MODIFICATION BULLETIN NO. BRO-001ISSUED ON Jan. 31, 1996

Model	<b>Fax170 / 180 ( China )</b>					Date of Modification	
Modified Article	FCU					<b>Execution Date</b>	
Reason for Modification	<input type="checkbox"/> Parts catalog correction <input type="checkbox"/> To meet standards (      ) <input type="checkbox"/> To facilitate assembly <input type="checkbox"/> Vender change <input type="checkbox"/> Part standardization <input checked="" type="checkbox"/> To improve reliability <input type="checkbox"/> Other					From October production in 1995.

MODIFICATION BULLETIN NO. BRO-003ISSUED ON Feb. 29, 1996

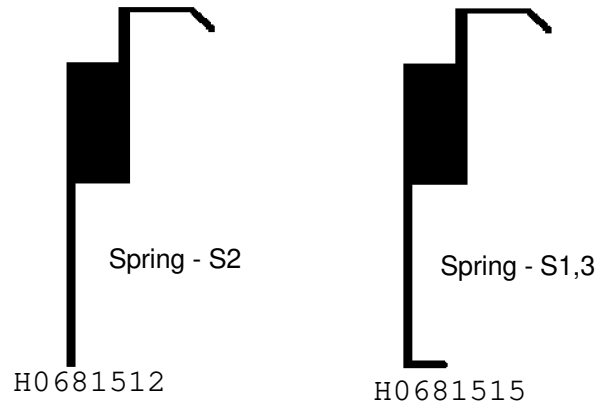
Model	<b>BRO/BR1</b>						Date of Modification		
Modified Article	ROM						<b>Execution Date</b>		
Reason for Modification	<input type="checkbox"/> Parts catalog correction <input type="checkbox"/> To meet standards (      ) <input type="checkbox"/> To facilitate assembly <input type="checkbox"/> Vender change <input type="checkbox"/> Part standardization <input checked="" type="checkbox"/> To improve reliability <input type="checkbox"/> Other						From April production in 1996.		
		See RTB BRO-005.

Old Part No.	New Part No.	Description	Q'ty Used Old → New	Interchange- ability	Remarks	Parts Catalog	
						Index No.	Page
H068 6000R	H068 6000S	PCB-FCU - Asia	1 → 1	X / O	BRO	5	1-8
H068 7200F	H068 7200G	Programmed ROM	( 1 → 1 )	( X / O )			
H068 6001P	H068 6001Q	PCB-FCU - China	1 → 1	X / O	BRO	5	1-8
H068 7201E	H068 7201F	Programmed ROM	( 1 → 1 )	( X / O )			
H068 6080C	H068 6080D	PCB-FCU - US	1 → 1	X / O	BRO	5	1-8
H068 7200F	H068 7200G	Programmed ROM	( 1 → 1 )	( X / O )			
H069 6000N	H069 6000P	PCB-FCU - Asia	1 → 1	X / O	BR1	5	1-8
H069 7200D	H069 7200E	Programmed ROM	( 1 → 1 )	( X / O )			
H069 6001N	H069 6001P	PCB-FCU - China	1 → 1	X / O	BR1	5	1-8
H069 7211B	H069 7211C	Programmed ROM	( 1 → 1 )	( X / O )

MODIFICATION BULLETIN NO. BRO - 005ISSUED ON 31.Jul,1996

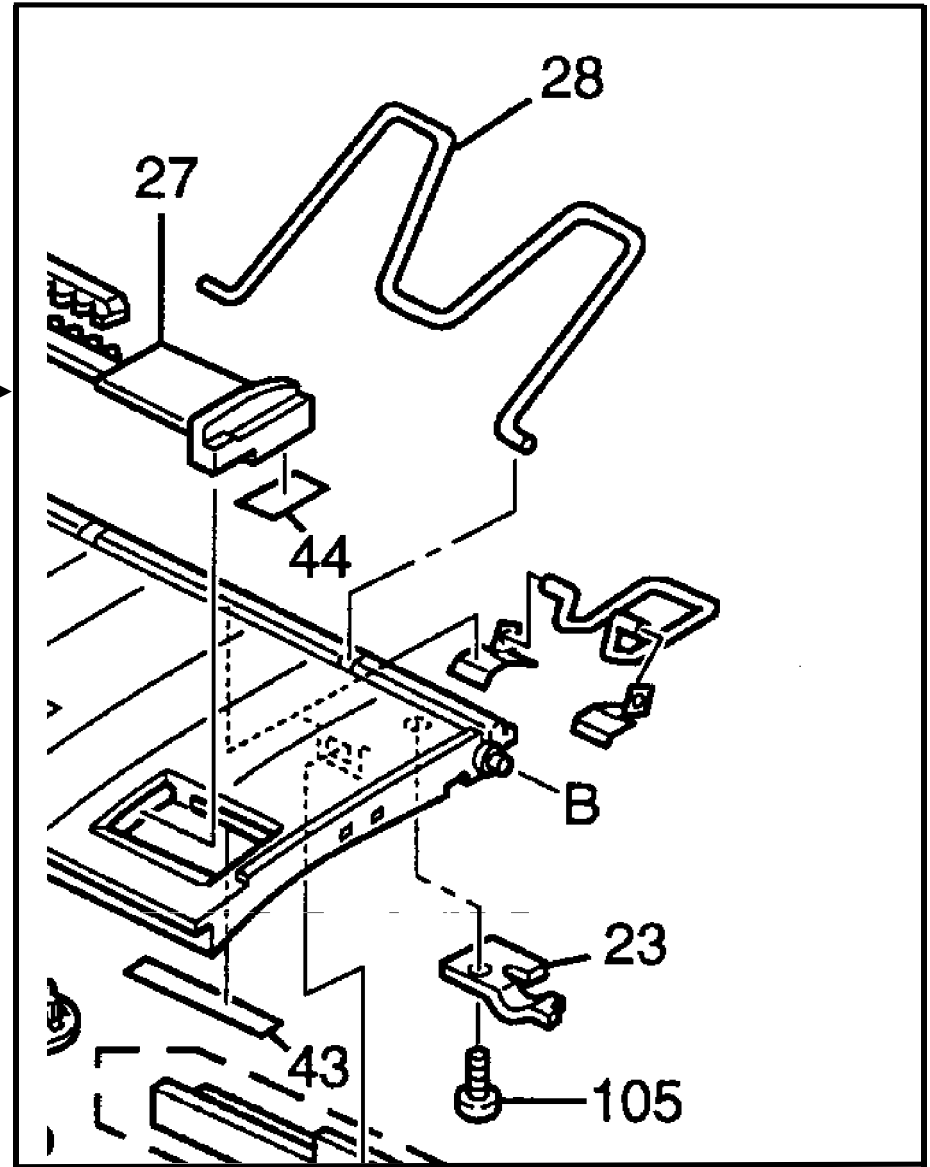
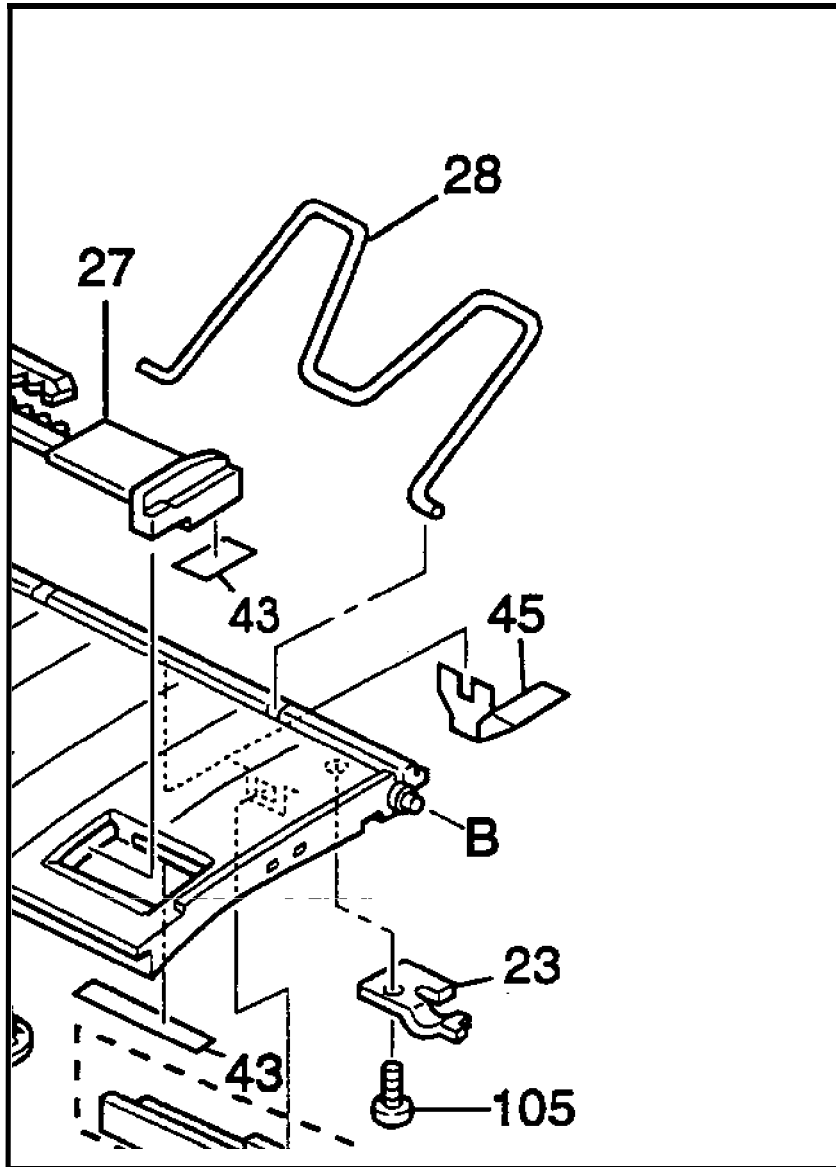
<b>Model</b>	<b>BRO / BR1 (Except China)</b>					<b>Modification Schedule</b>	
<b>Modified Article</b>	Exterior					After the old parts are out of stock.	
<b>Reason for Modification</b>	<input type="checkbox"/> Parts catalog correction <input type="checkbox"/> To meet standards (      ) <input type="checkbox"/> To facilitate assembly <input type="checkbox"/> Vender change <input type="checkbox"/> Part standardization <input checked="" type="checkbox"/> To improve reliability <input type="checkbox"/> Other						
To prevent deformation of the Exit Guide.

Old Part No.	New Part No.	Description	Q'ty Used Old → New	Interchange- ability	Remarks	Parts Catalog	
						Index No.	Page
H0682137	H0682141	Exit Guide	1	O / O	In combination	45	4
	H0682142	Bracket - Exit Guide - LEFT	1			X	
	H0682143	Bracket - Exit Guide - RIGHT	1			Y

**MODIFICATION BULLETIN NO. BRO - 008**

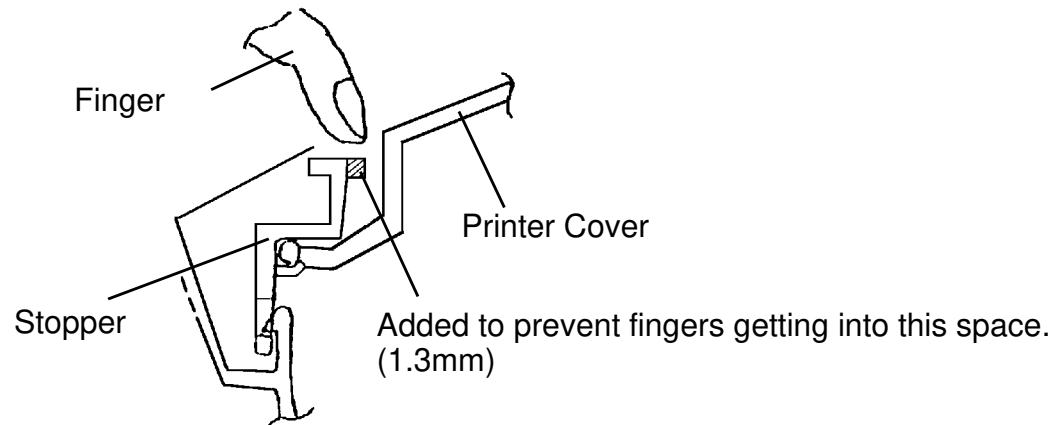
Model	<b>BRO, BR1, (ASIA, China)</b>			Modification Schedule	
Modified Article	PSU			After the old part is out of stock.	
Reason for Modification	<input type="checkbox"/> Parts catalog correction <input type="checkbox"/> To meet standards (      ) <input type="checkbox"/> To facilitate assembly <input type="checkbox"/> Vender change <input checked="" type="checkbox"/> Part standardization <input type="checkbox"/> To improve reliability <input type="checkbox"/> Other

Old Part No.	New Part No.	Description	Q'ty Used Old → New	Interchange- ability	Remarks	Parts Catalog	
						Index No.	Page
H0685001	H0685003	PCB - PSU - 220V	1 - 1	O / O		6	7
